Pilot Region-Based Optimization Program for Fund-Lead Sites in EPA Region 3

Site Optimization Tracker: Greenwood Chemical Site Newtown, Virginia

Solid Waste and
Emergency Response
(5102P)

EPA 542-R-06-006d
December 2006
www.epa.gov

FIGURE 1-1. THE GREENWOOD CHEMICAL SITE AND WELL LOCATIONS.

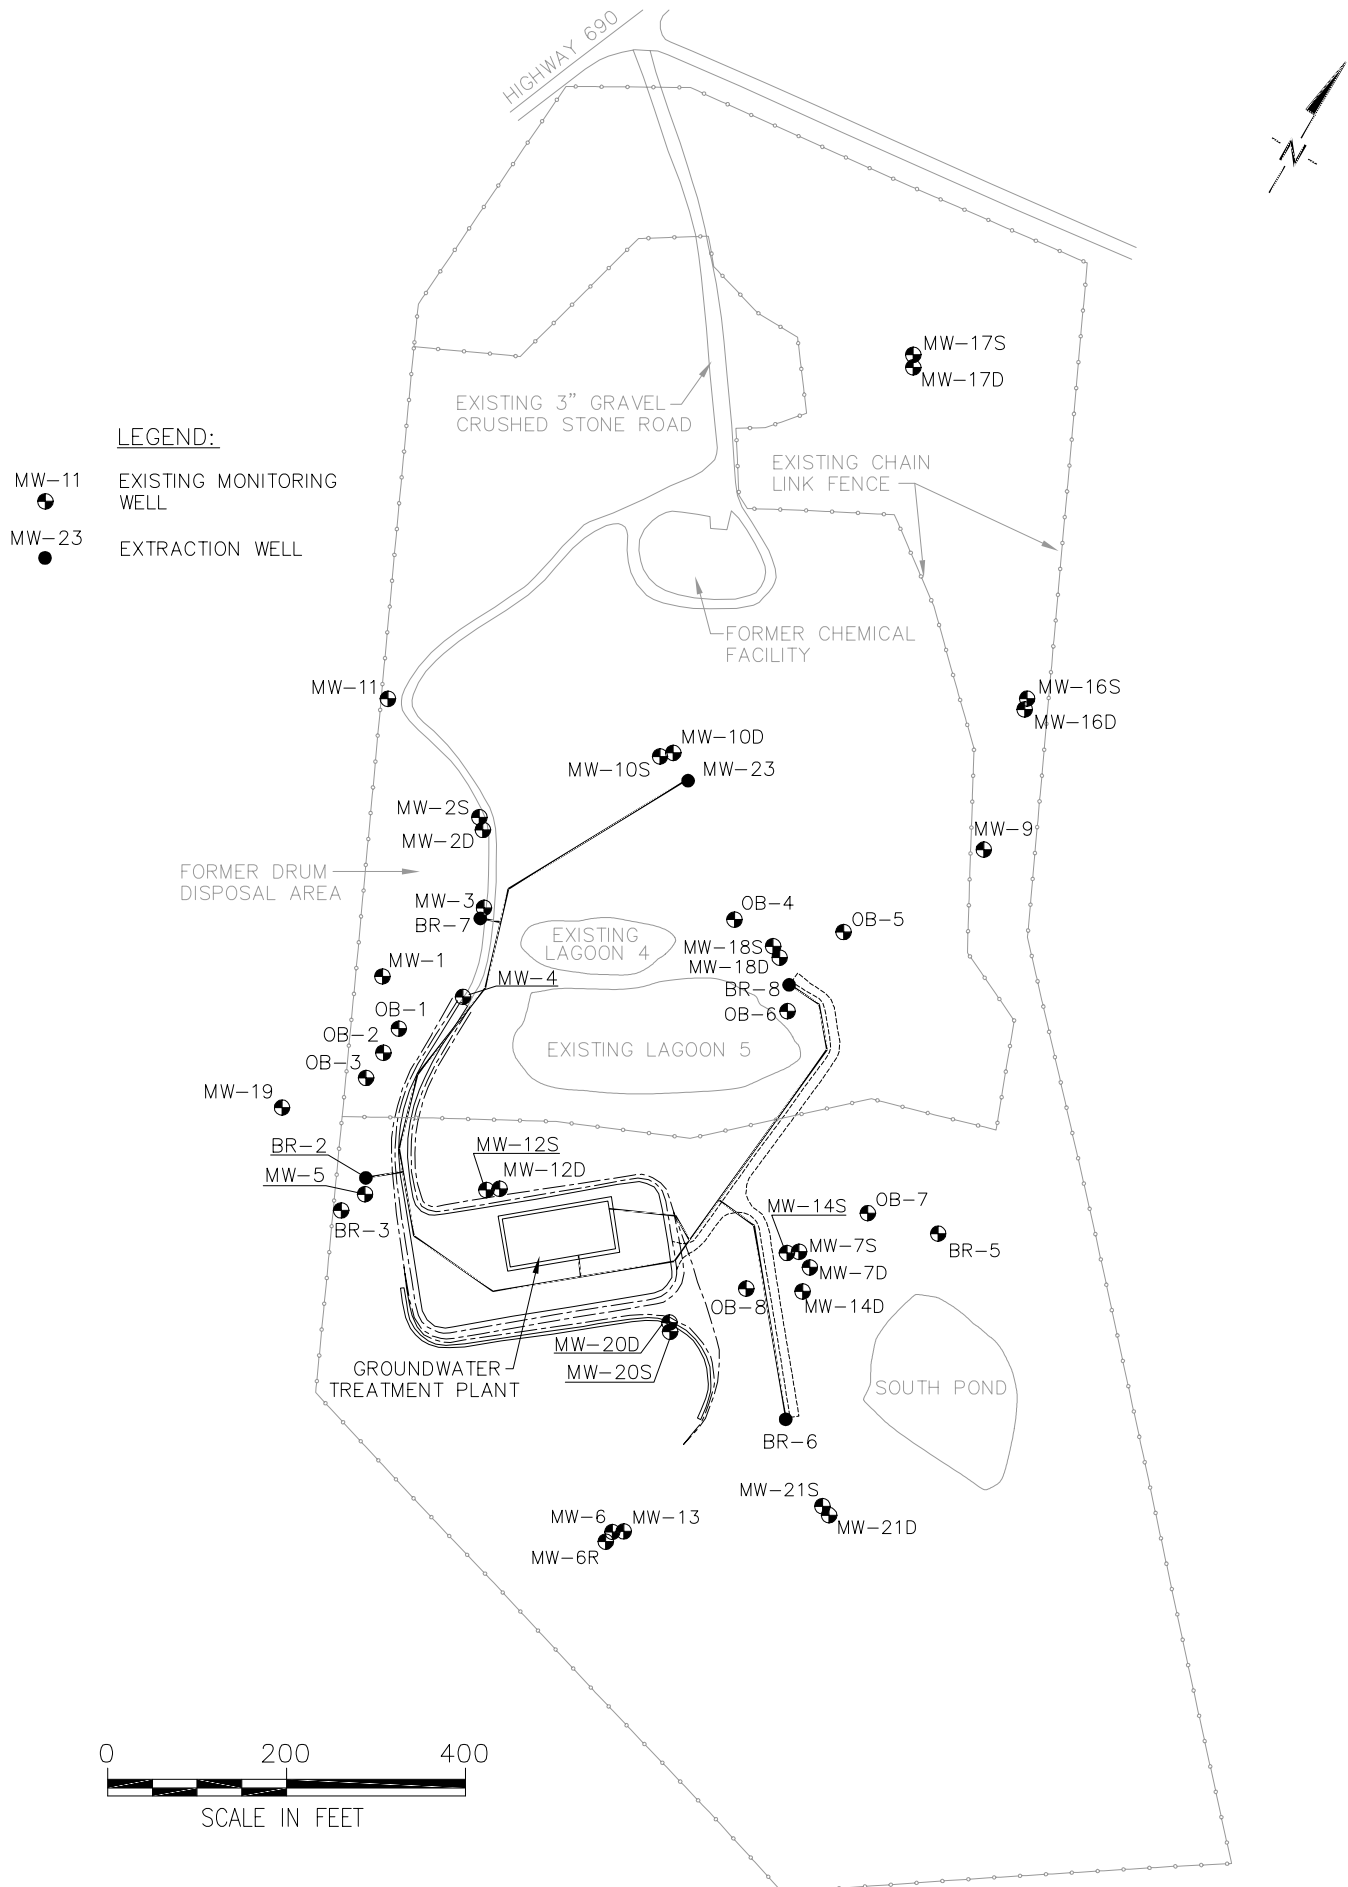
The ground water extraction system recovers ground water from five bedrock extraction wells (BR-2, BR-6, BR-7, BR-8, and MW-23) that are depicted in Figure 1-1. Each well is piped to the plant separately with a flow meter on each line. In addition, a floating pump assembly allows for extraction from Lagoon 5 (Lagoon 4 is hydraulically connected to Lagoon 5) to prevent overflow during precipitation events. The treatment system provides for metals and solids removal, destruction of organic contaminants via UV oxidation, and sorption of remaining organic contaminants to GAC. Treated effluent is discharged to the West Branch of Stockton Creek, located south of the site.

At this site, the plume has not been fully delineated and a target capture zone has not been established. As indicated in Figure 1-2, contamination is present above site-specific standards (and above MCLs) at MW-21S and MW-21D. Contamination (albeit at low concentrations) is also present in BR-2, which is an extraction well that marks the furthest downgradient sampling point (in recent sampling events) on the western side of the property. Many of the deep wells at the site also have contamination with no deeper wells to provide delineation. MW-7D and MW-21D are examples of such wells. The concentrations at MW-7D and MW-21D are higher than at MW-7S and MW-21S (respectively), and it is possible that concentrations below MW-7D and MW-21D might actually increase with depth. The MW-14 cluster, which is adjacent to the MW-7 cluster, has bedrock wells which are deeper than those of the MW-7 cluster, but the sampling data from the past year (4 quarters) indicate that the MW-14 cluster has not been sampled.

We recommend installing additional monitoring wells for delineation. Two clusters of monitoring wells at three depths should be installed downgradient of MW-21D (perhaps 200 to 400 feet downgradient depending on accessibility). The shallow and intermediate wells in each of these clusters might be completed to depths that are comparable to MW-21S and MW-21D. The depths of the deeper wells in each of the clusters would likely need to be determined in the field, but sampling MW-14D prior to the drilling event may provide useful information. MW-14D is located approximately 200 feet upgradient of MW-21D but the elevation of the base of the screen for MW-14D is 140 feet deeper than that of MW-21D. The data reviewed by the OSE team suggested that MW-14D has not been sampled recently. Depending on the results from MW-14D, the site team might consider drilling to a depth of 100 to 200
